Access Compliance Report

Public Rights-of-Way

Intersection ID: 17241	Main Street: S_CANTERBURY_RD	Cross Street: S_WENDOVER_RD	Location: SE
ADA ID: 19D74C5A9E3E	Ramp Type: Directional1	Initial Pass/Fail: Fail	Overall Compliance: No
Severity Score: 1.25			
Codes/Mitigation Info/Possible Solution		Field Measurements/Component Compliance

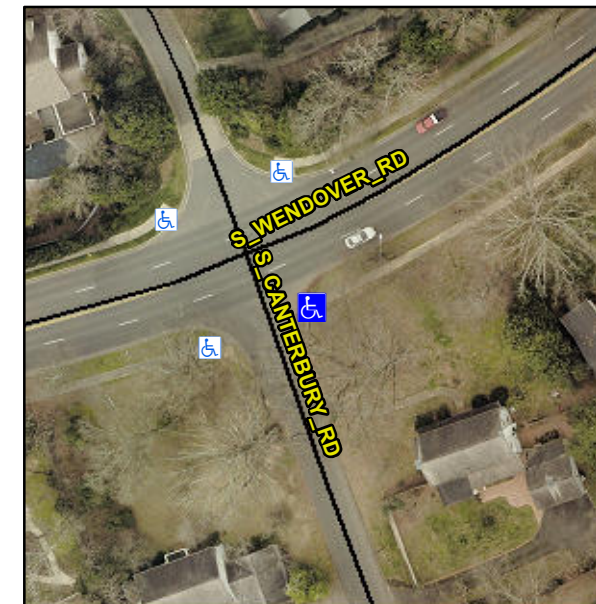
R304.5.3

Compliance	Description	Data	Compliance	Description	Data
N/A	Ramp Length (in)	57.0	N/A	Grade Break?	N/A
Yes	Ramp Width (in)	57.0	N/A	Grade Break Slope (%)	0.0
Yes	Ramp Slope (%)	6.6	N/A	Grade Break XSlope (%)	0.0
No	Ramp XSlope (%)	2.6			
N/A	Flare Type LT	N/A	N/A	Flare Type RT	N/A
N/A	Flare Slope LT (%)	N/A	N/A	Flare Slope RT (%)	0.0
N/A	Flare Traversable LT?	N/A	N/A	Flare Traversable RT?	N/A
N/A	Landing Length (in)	0.0	N/A	DWS Provided?	N/A
N/A	Landing Width (in)	0.0	N/A	DWS Contrast?	N/A
N/A	Landing Slope (%)	0.0	N/A	DWS Length (in)	N/A
N/A	Landing X Slope (%)	0.0	N/A	DWS Full Width?	N/A
N/A	Landing Curb? (Y/N)	N/A	N/A	DWS Offset LT (in)	N/A
N/A	Shared Landing?	N/A	N/A	DWS Offset RT (in)	N/A
N/A	Gutter Ponding?	0.0	N/A	Gutter Slope (%)	N/A
N/A	Gutter Lip Ht (in)	0.0	N/A	Gutter X Slope (%)	N/A
N/A	Painted X Walk1?	No		Road Slope (%)	1.8
	X Walk 1 Direction	To SW		Road X Slope (%)	0.7
	X Walk 1 Width (in)	N/A		Clear Space?	N/A

X Walk 1 Slope (%)	1.8	N/A	Clear Space to XWalk (in)	N/A
	X Walk 1 X Slope (%)	0.7	N/A	Storm Grate/Utility Hazard?	N/A
N/A	Ramp inside XWalk1?	N/A		Storm Grate/Utility Type	
N/A	Any Obstructions?	N/A			N/A
	Obstruction Type		Yes	Surface Condition? (G/P)	Good
			N/A	Curb Slope (%)	12.6

Remove & Replace Entire Ramp.
